Product Change Notice (PCN)

Subject: Product marking change from Ink Mark to Laser Mark

Publication Date: 7/21/2022

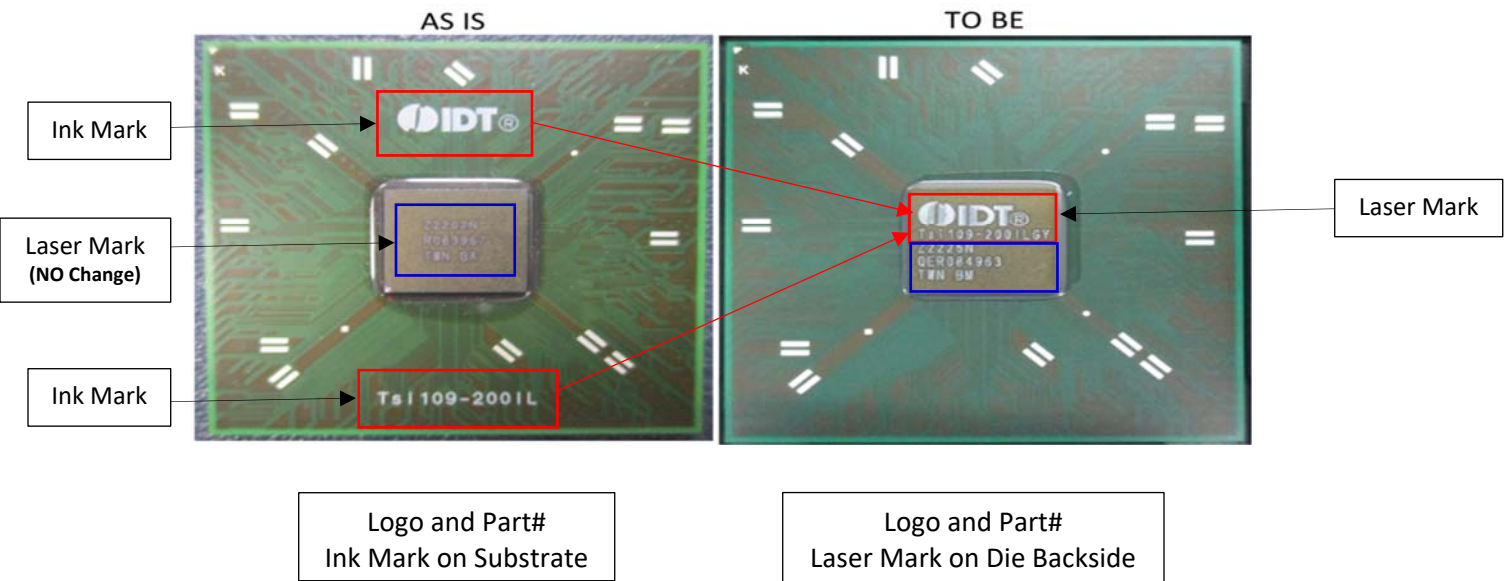
Renesas is changing from ink mark to laser mark on select products as a result of marking ink being phased out. Presently, “IDT” logo and product part# are ink marked on the substrate. This two information will change to laser marked on the die backside.

No change to the rest of marking as highlighted in blue box depicted in the below image.

Refer below for the marking appearance comparison.
